BOARD OF COUNTY COMMISSIONERS
ORANGE COUNTY, FLORIDA

ADDENDUM NO. 3 / IFB NO. Y18-758-TA

SOUTH SERVICE AREA/EAST SERVICE AREA (SSA/ESA) 36-INCH POTABLE
WATER MAIN, 24-INCH RECLAIMED WATER MAIN AND J. LAWSON BLVD
POTABLE WATER RE-PUMP FACILITY

PCP EQUIPMENT VIEWS
SCALE: 3/4"=1'-0"
6" 0 1 2'

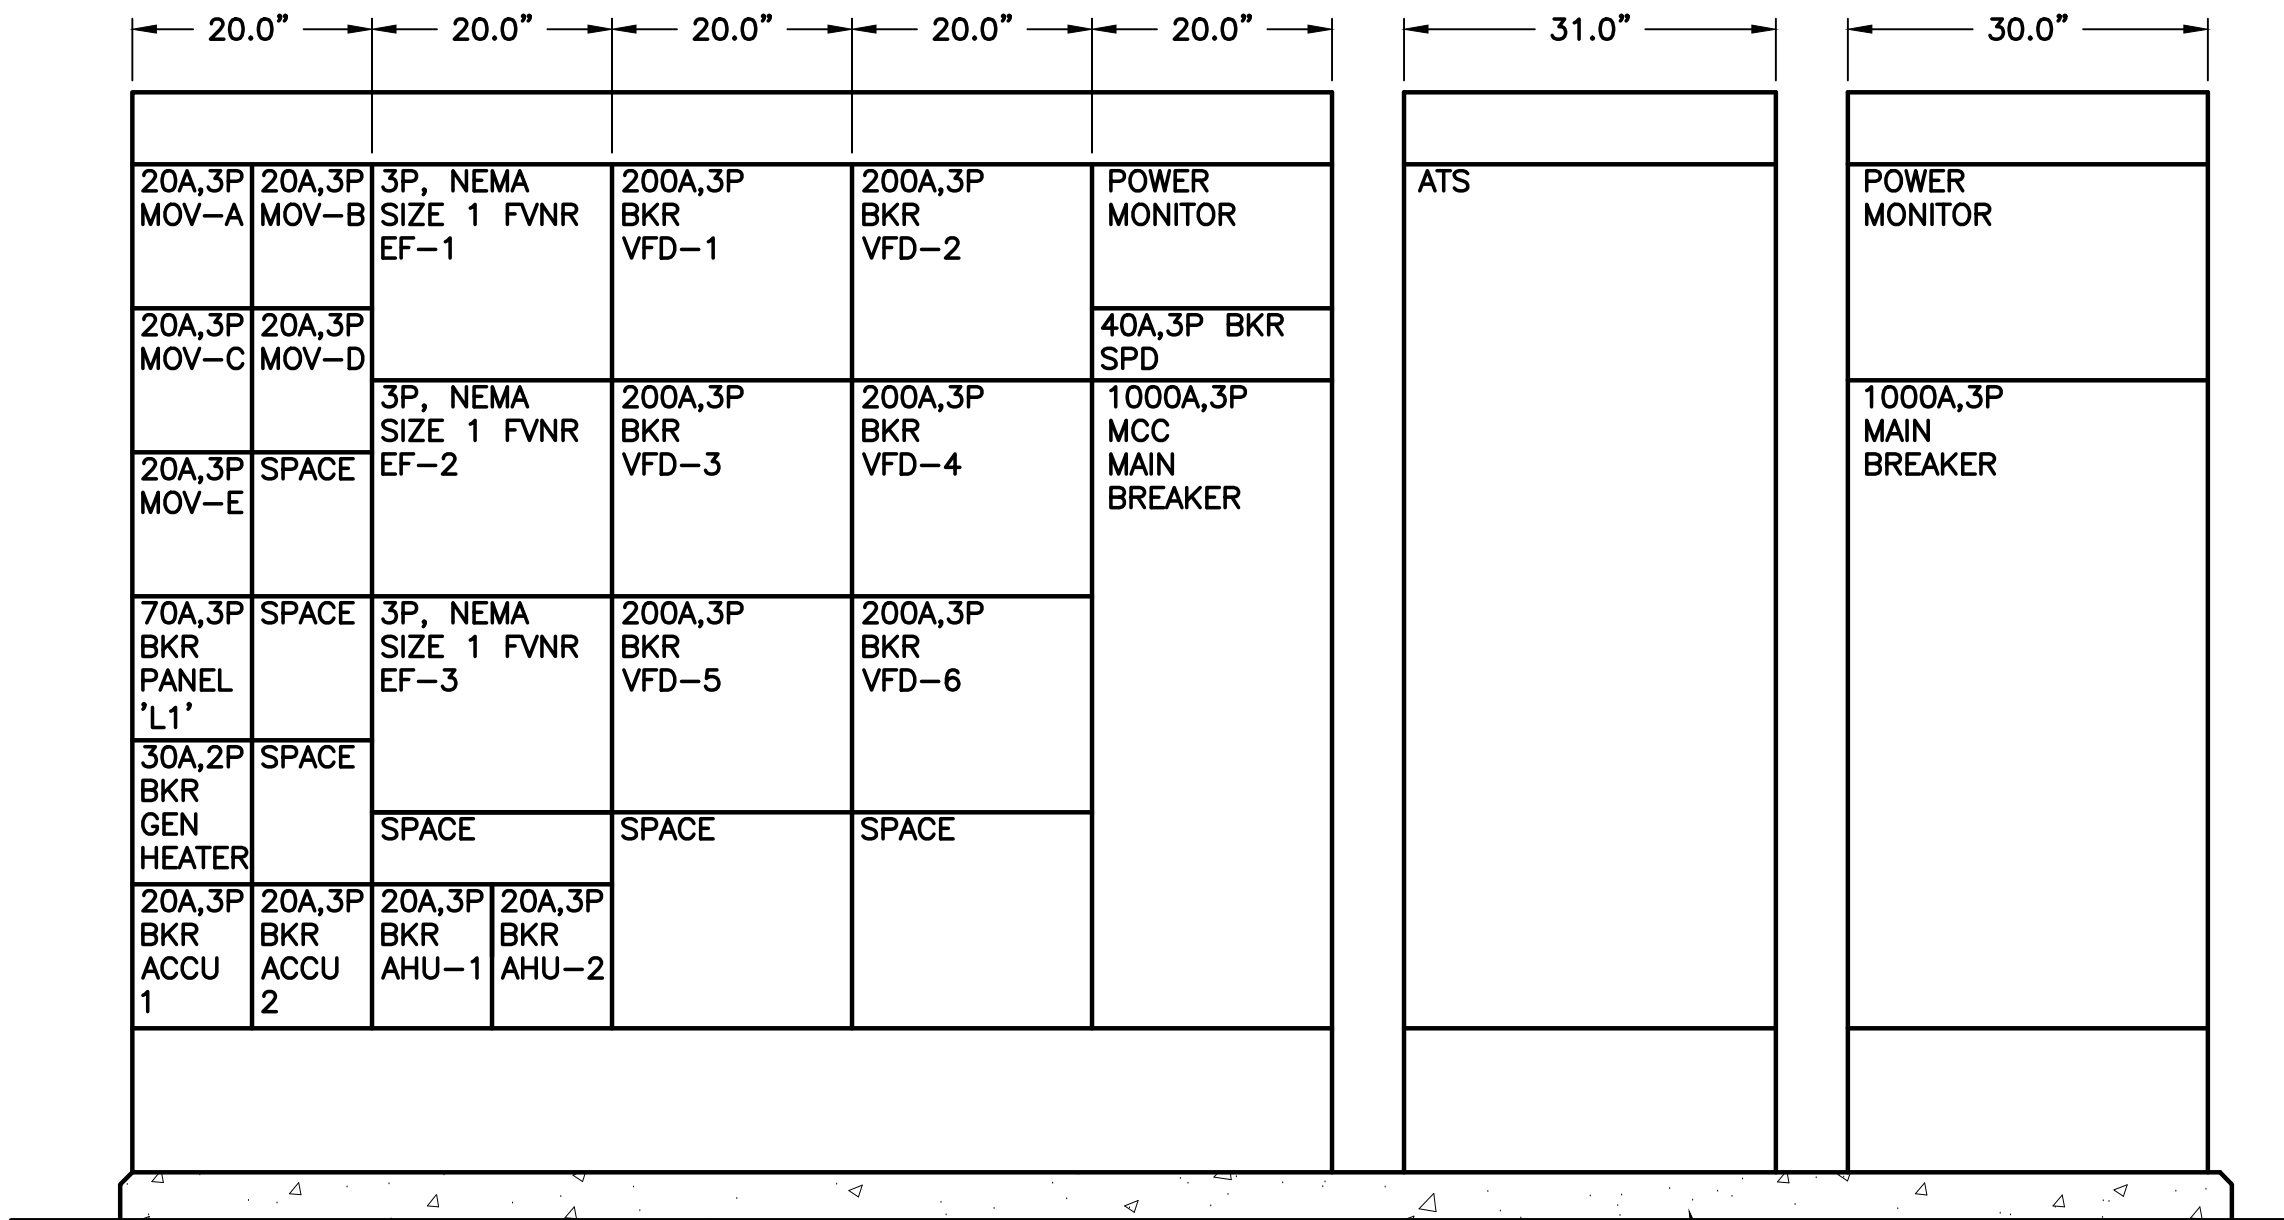
9. Q: I-02 show the VFD I/O being transmitted via Ethernet whereas E-05 shows a hardwire connection; please clarify which is to be used.

DRAWINGS E-04, E-05, and I-02

A: VFD I/O to be transmitted via Ethernet except the Pump start/stop (control) which is to be hardwired. See revised drawings E-04, E-05, and I-02.

Amend: Delete drawings E-04, E-05, and I-02 and replace with the revised Drawings E-04, E-05, and I-02. The revised drawings show the VFD I/O to be transmitted via Ethernet and the Pump start/stop (control) being hardwired.

SCALE: AS SHOWN
 DRAWING NO.:
E-07
 SHEET: 164 OF 292

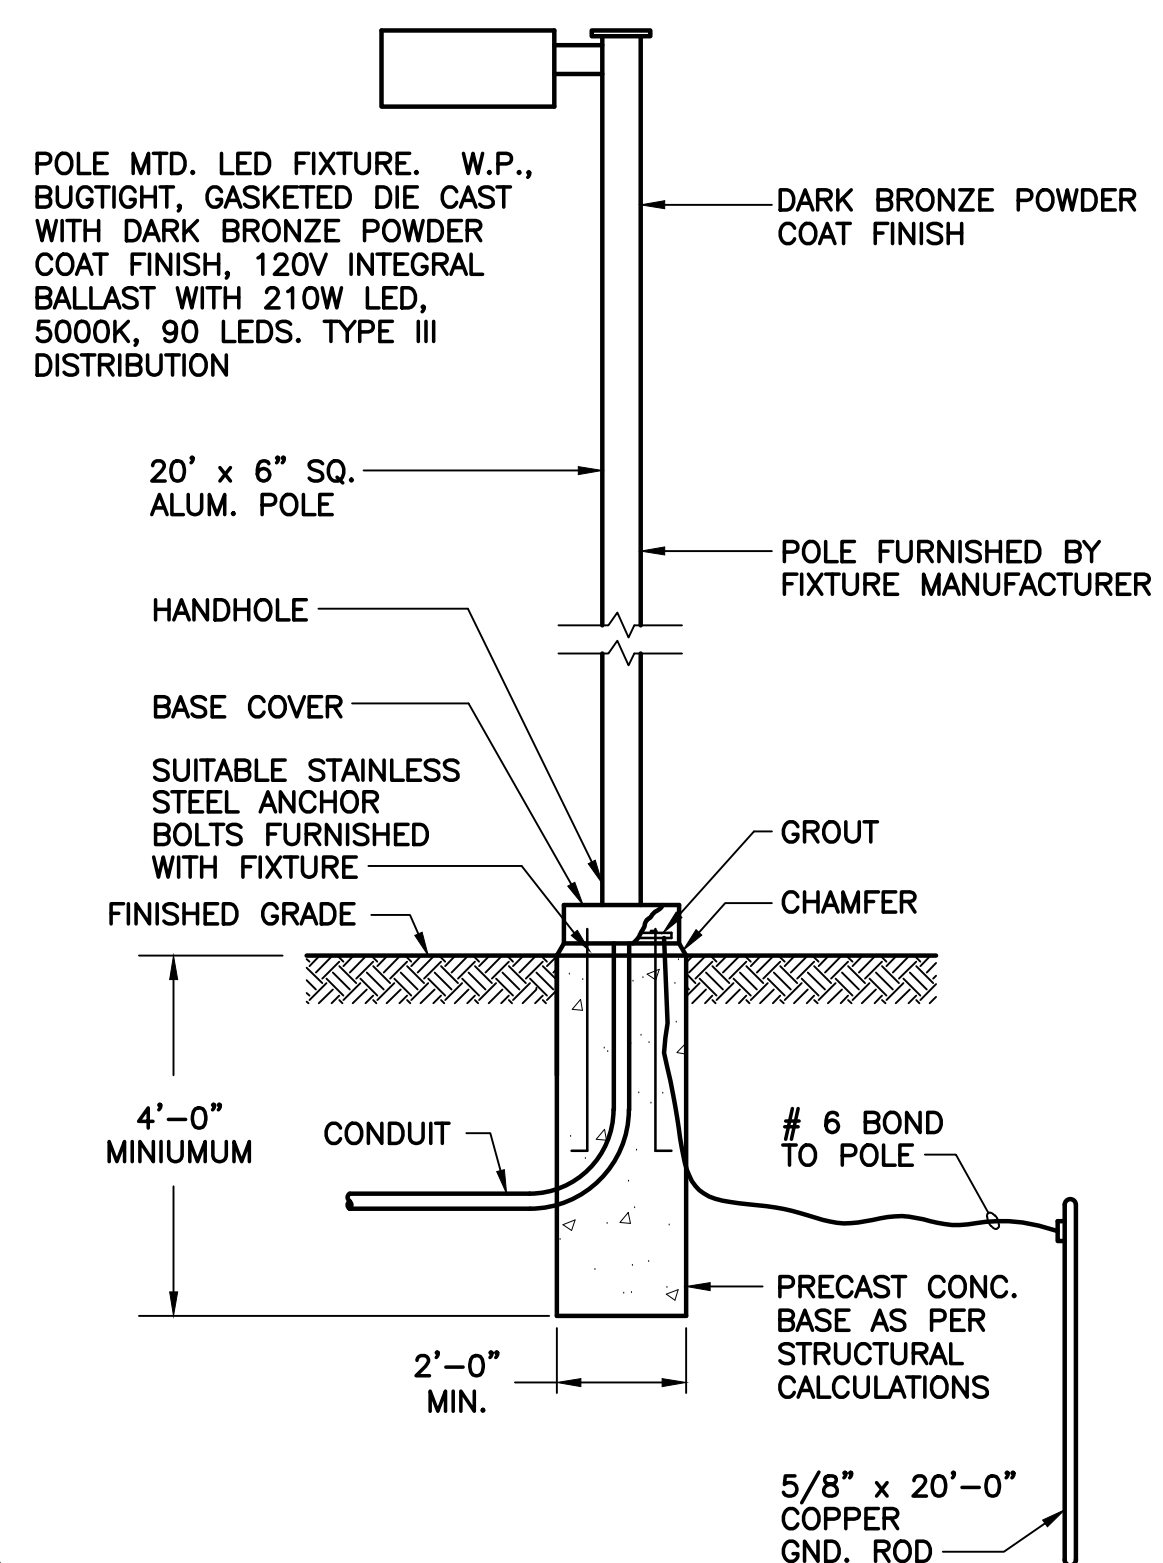
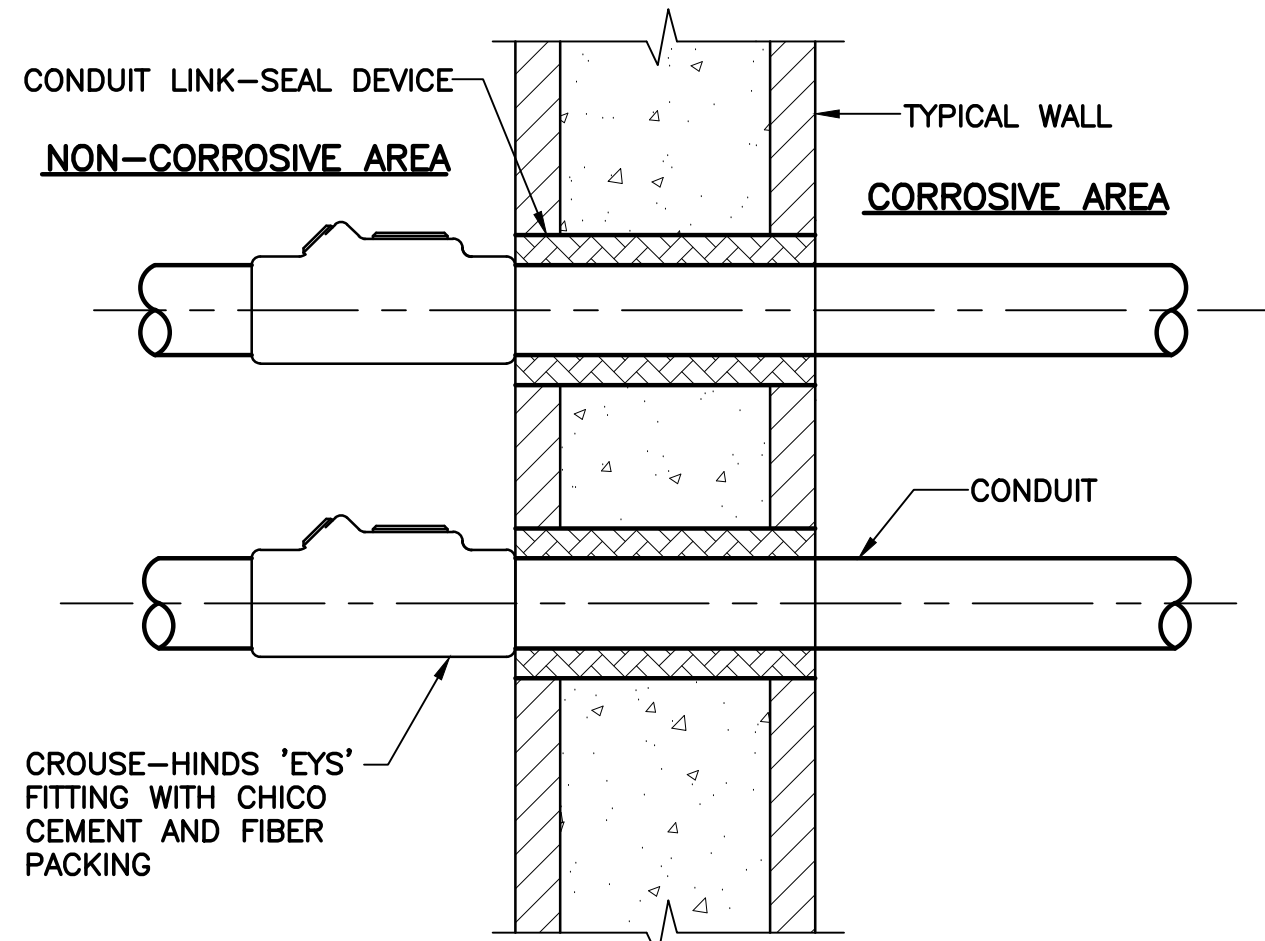
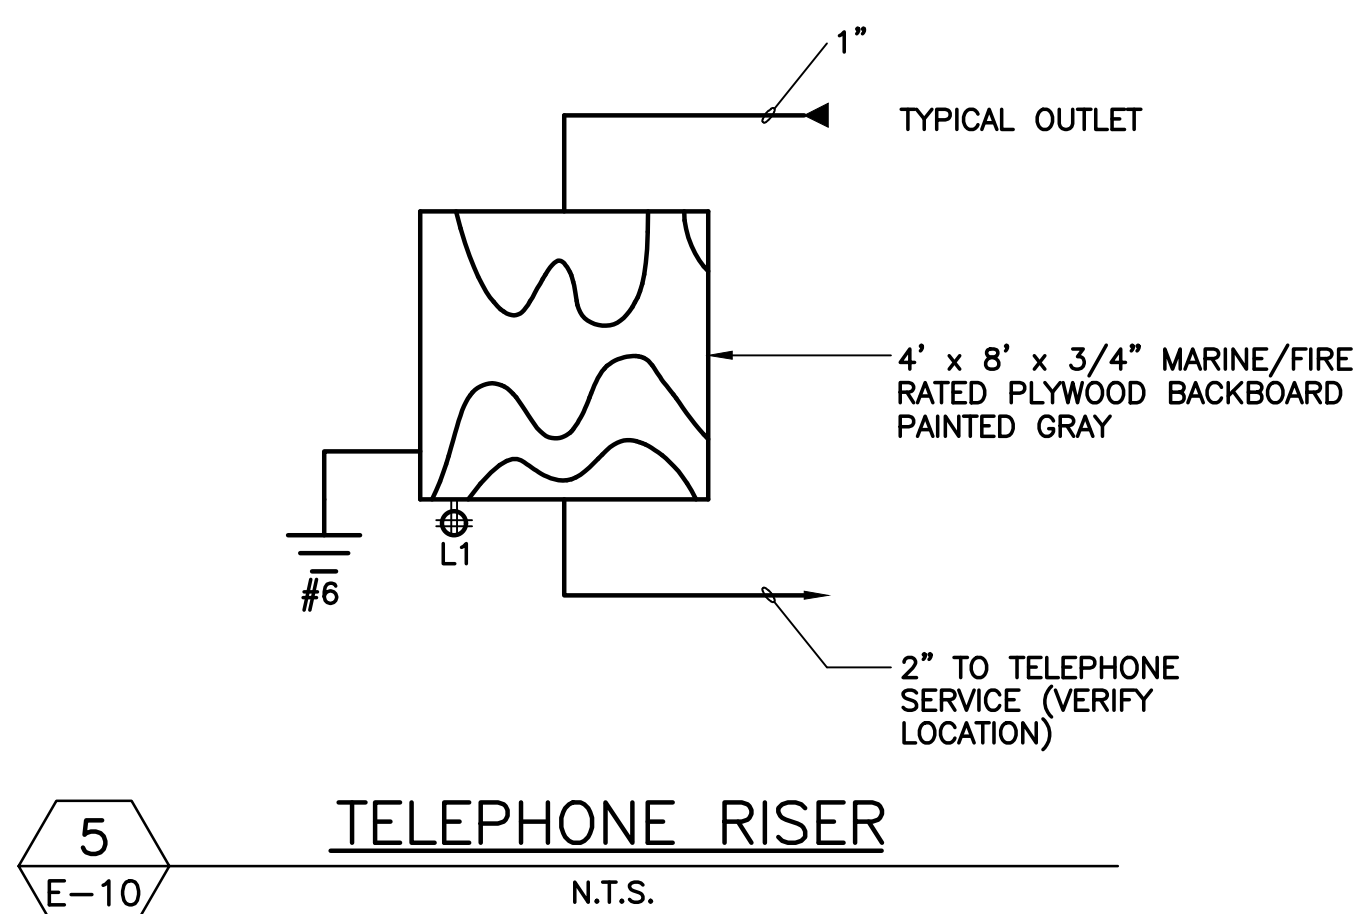
DRAWING A1.0, E-07, and E-10

Amend: Delete drawings A1.0, E-07, and E-10 and replace with the revised drawings A1.0, E-07, and E-10. The revised drawings show the overhead door 103B on A1.0 being electrically operated and power running to the overhead door.
